REGULAR MEETING OF THE PLANNING BOARD WEDNESDAY – MAY 25, 2016 7:30 PM CITY COMMISSION ROOM 151 MARTIN STREET, BIRMINGHAM

T City	of Birmingham	MEMORANDUM
		Planning Department
DATE:	May 19, 2016	
то:	Planning Board	
FROM:	Sean Campbell, Assistant Planner	
SUBJECT:	Final Site Plan & Design Review and Specia Bar	I Land Use Permit - Corner

City	of Birmingham	MEMORANDUM
		Planning Division
DATE:	May 16, 2016	
TO:	Planning Board members	
FROM:	Jana Ecker, Planning	
SUBJECT:	856 N. Old Woodward Revised Preliminary Site Plan Review (ch	anges in blue type)

A001

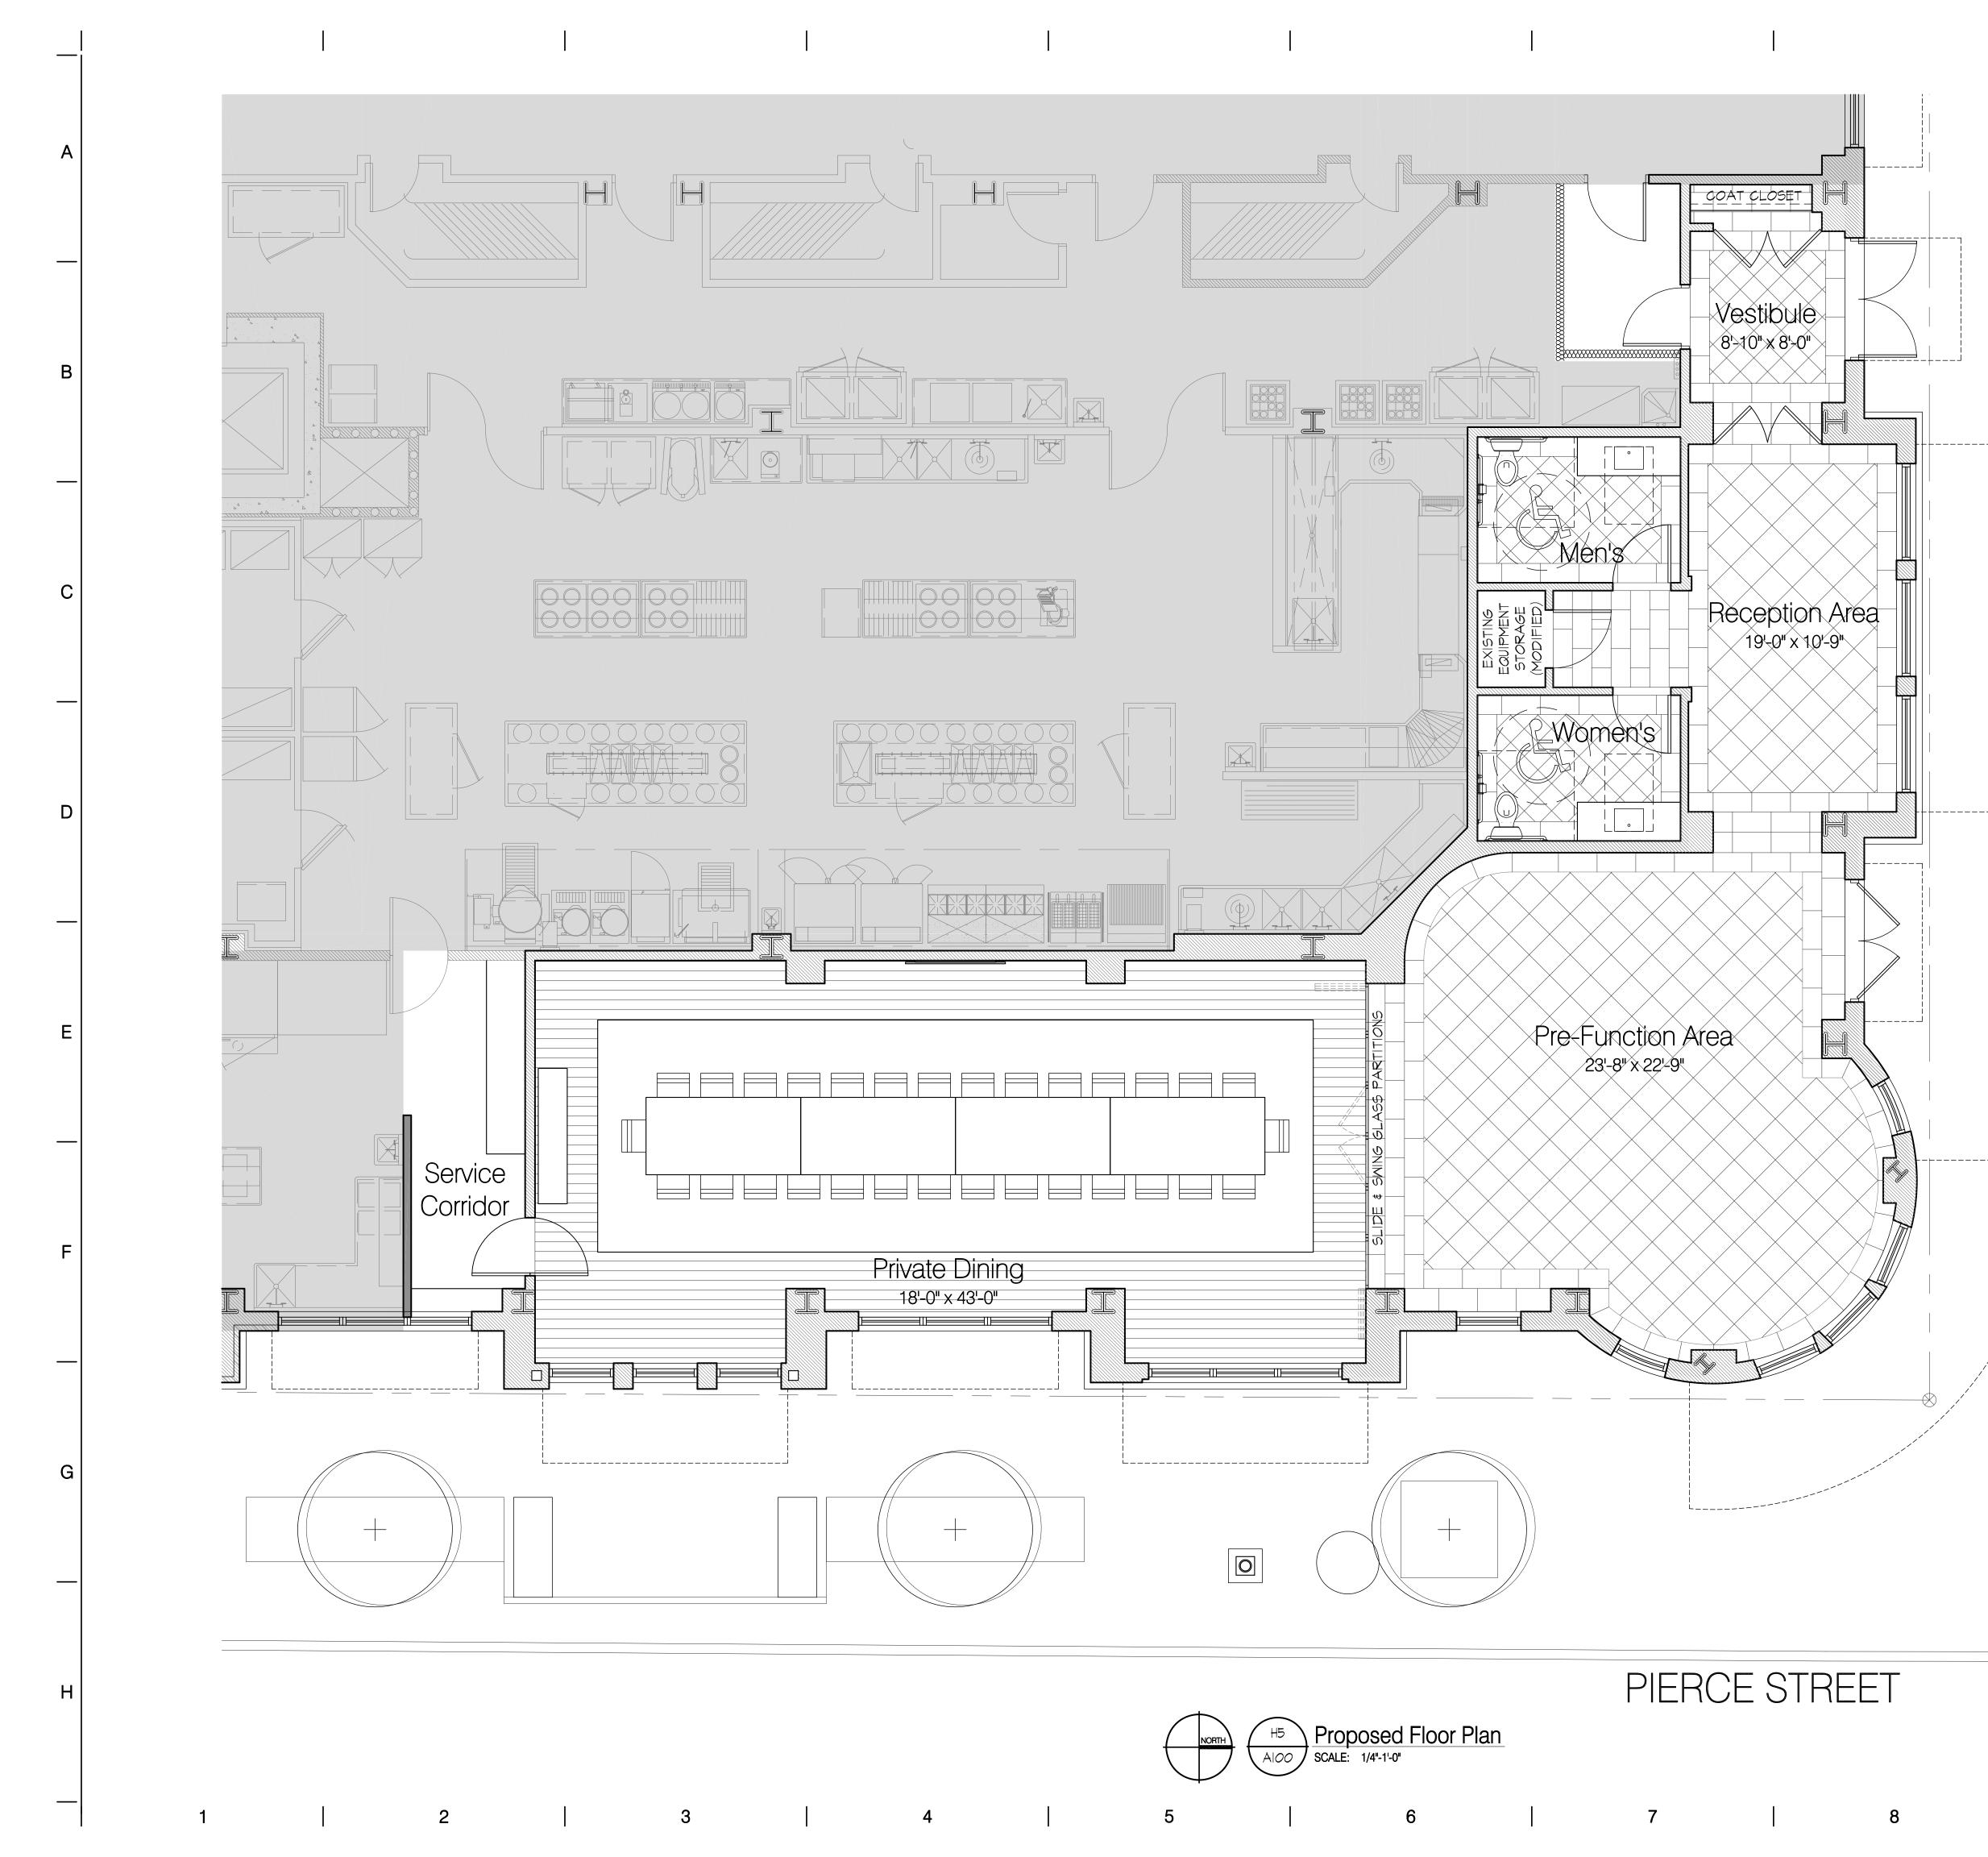
- 2.1 <u>Dumpster Screening</u> The proposed plans do not indicate any new outdoor trash receptacles.
- 2.2 <u>Parking Lot Screening</u> The subject site is located in the Parking Assessment District, which does not require on-site parking for commercial uses. The required parking will be provided in a public parking facility and therefore does not require any screening.
- 2.3 <u>Mechanical Equipment Screening</u> The applicant does not propose any rooftop or grounded-mounted mechanical equipment. Thus, no mechanical screening is required.
- 2.4 <u>Landscaping</u> In Accordance with Article, Section 4.20 (C) (1) of the Zoning Ordinance, properties located in the Downtown Birmingham Overlay District are not required to provide any plantings. However, the applicant proposes one (1) Boxwood Topiary to be placed on each side of the door on the north elevation.

- 3.2 <u>Loading</u> The proposed remodel of the subject site neither requires nor indicates a loading space.
- 3.3 <u>Vehicular Access & Circulation</u> Vehicular access to the building will not be altered.
- 3.4 <u>Pedestrian Access & Circulation</u> –Pedestrian access is made available via sidewalks along Pierce and Merrill. City sidewalks will connect to two entrances along the north elevation of the subject building. The existing corner entrance and step will be eliminated.
- 3.5 <u>Streetscape</u> The applicant is proposing two new rectangular 18" x 18" x 18" lead planters to flank the new entrance. One new street tree will also be added.

BENJAMIN MOORE GRAY 2121-10

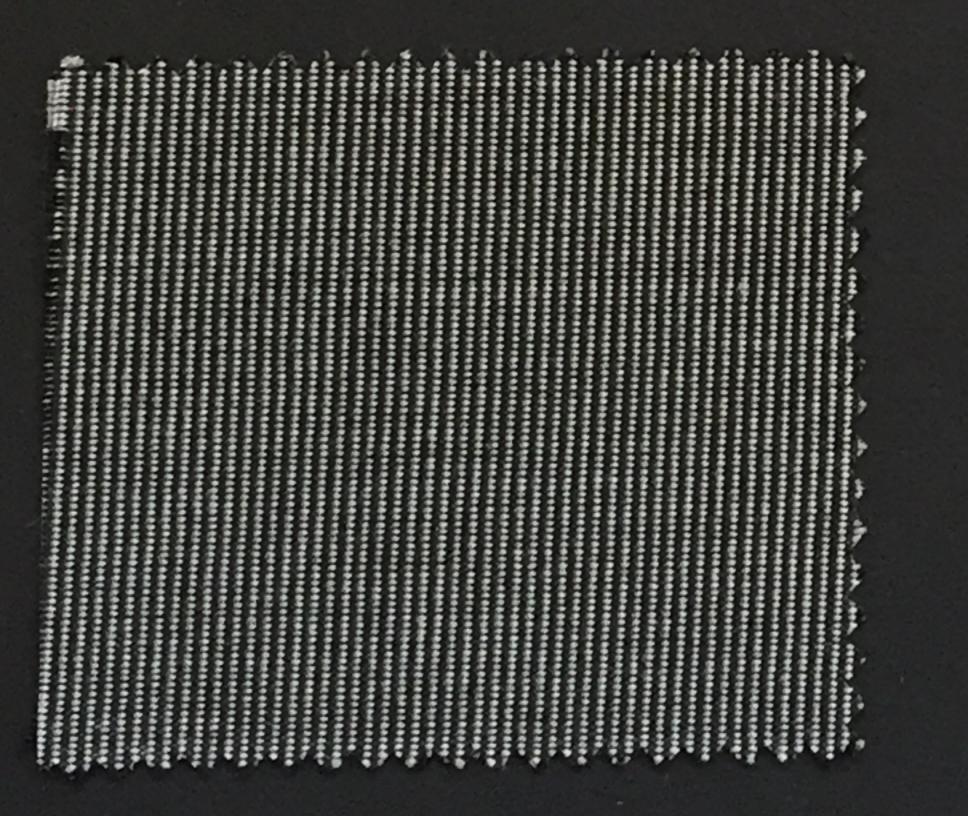
The applicant proposes to remove the revolving door and adjoining staircase located at the corner of Pierce St. and Merrill St. and replace it with three (3) $2' \times 6.5'$ windows; add three (3) new 2.25' x 2' windows above the existing metal entrance canopy; build out the entrance with 30 sq. ft. of matching limestone to align with existing curved building corner frontage; replace wood framed windows next on north elevation adjacent to entrance with two (2) 3' x 9' windows; replace existing wood doors at north elevation with two (2) new brass doors; insert two (2) boxwood plants on both sides of brass entry door; build a limestone border around the new brass entry door; replace the green fabric awning above the north elevation door with a 6" tall metal canopy; paint

both the existing and proposed metal canopies with Benjamin Moore "Gray" 2121-10; install 8" applied brushed stainless steel letters along the canopies at the corner entrance; and replace fabric on all existing awnings with Sunbrella Charcoal Tweed.

EAST (REAR) ELEVATION - OVERLOOKING THE ROUGE RIVER / PUBLIC LANDS -A NN2 1" = 10' - 0" 856 NORTH OLD WOODWARD AVENUE MIXED USE RETAIL - RESIDENTIAL DEVELOPMENT 05/06/2016

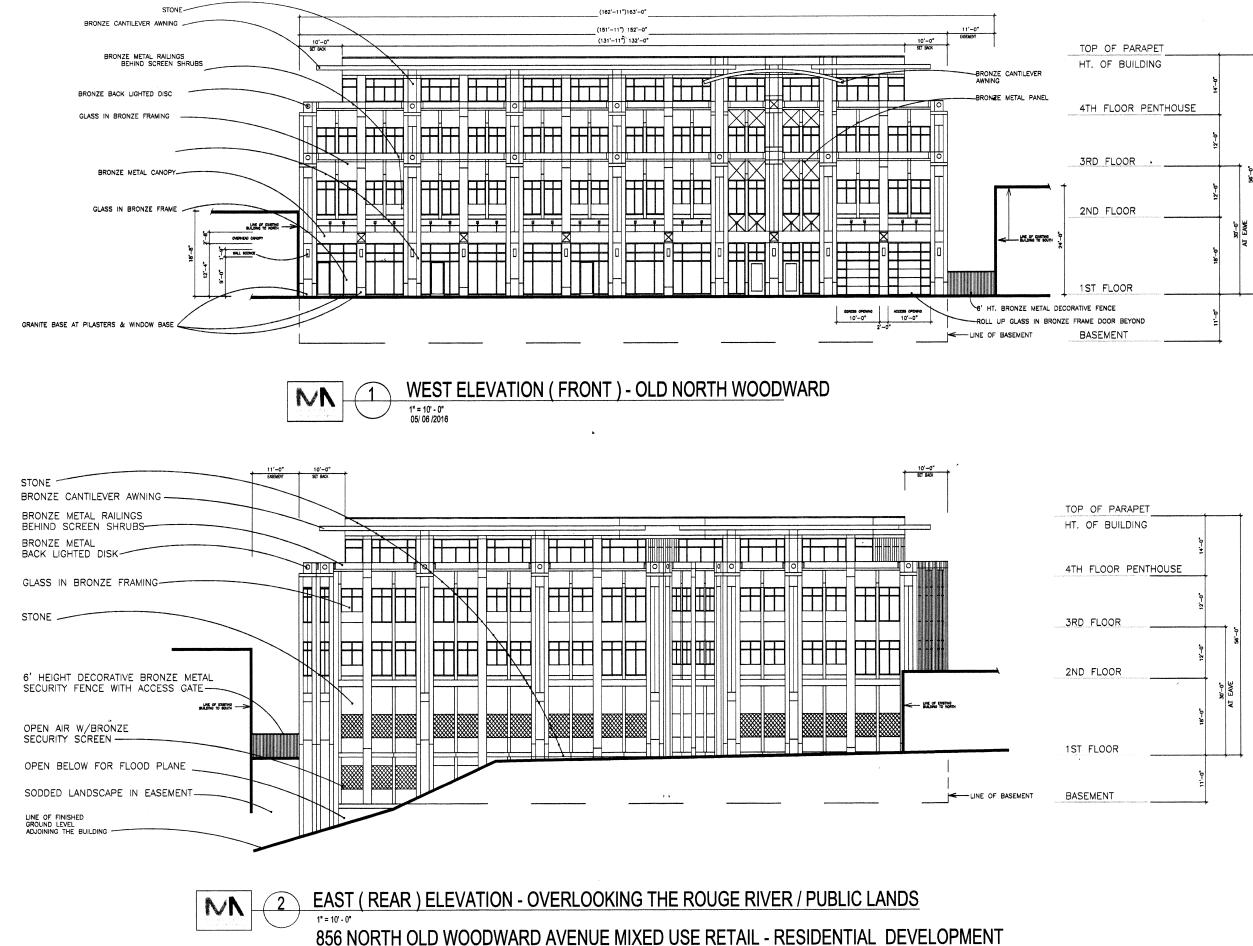
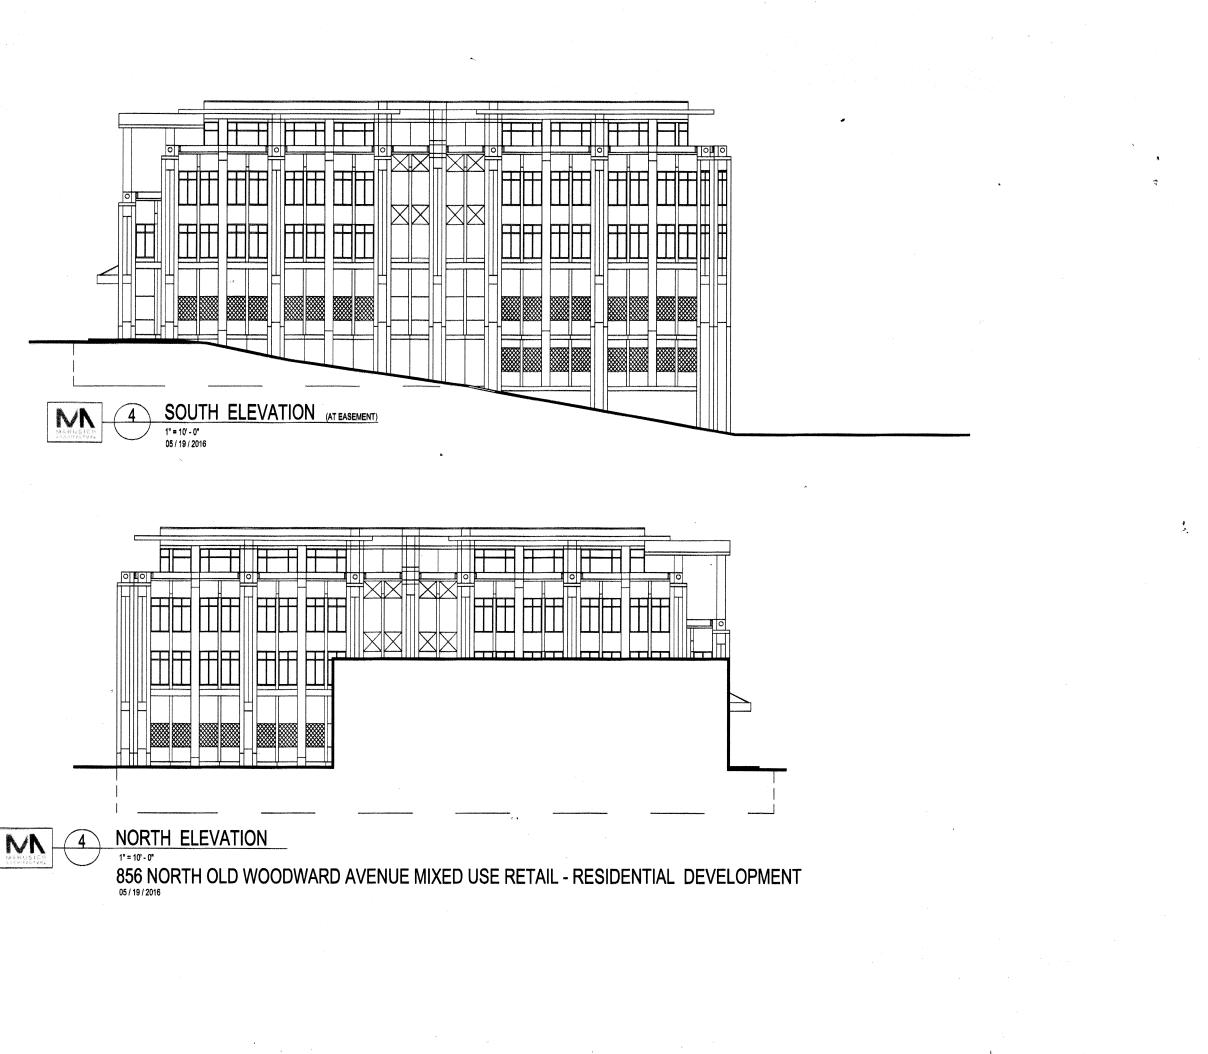
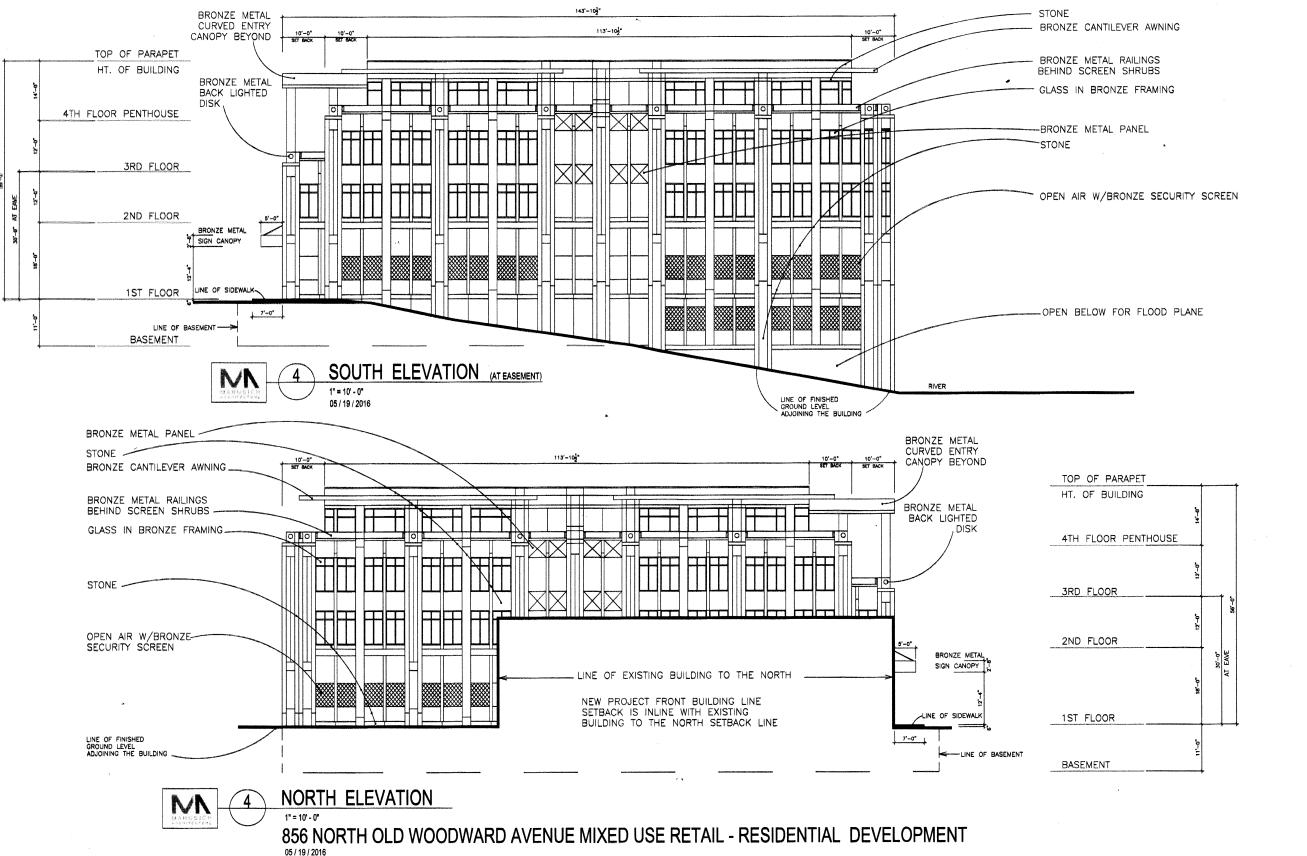
The building is not on the frontage line, however, it is **setback 10.8' (previously 22')**. In accordance with Article 3, section 3.04(B), the Planning Board may adjust the front setback to match the front setback of any abutting building **The applicant has now provided the front and rear setbacks for both adjacent buildings to the north and south**, and the proposed building must have a front and rear setback equal to the front and rear setback of any of the adjacent buildings. The front setback of the building to the north is 10.8', and the **rear setback of the building to the north is 10.8'**, and the **rear setback of the building to the south is 12.8'**. Thus, the proposed **building has front and rear setbacks equal to those of adjacent buildings as required**. The proposed development is in accordance with Article 4, Section 4.52 PK-08 as the first story off-street parking is located greater than 20' from the front façade and is masked by a 49' deep retail space.

- 3.3 <u>Mechanical Equipment Screening</u> One electrical transformer is now proposed at the rear of the property outside of the building (previously two were proposed within the building). The transformer will be screened by the building itself, but it will be visible from the river. No specifications have been provided for exterior mechanical equipment, but a rooftop plan has now been submitted.

The applicant has submitted a building section showing a 5' deep well (previously 10' deep) on the roof for rooftop mechanical equipment. The applicant has now provided a building section that shows the depth of the mechanical well and the height of the proposed rooftop mechanical equipment. The applicant will be required to provide specification sheets at the time of Final Site Plan and Design Review.
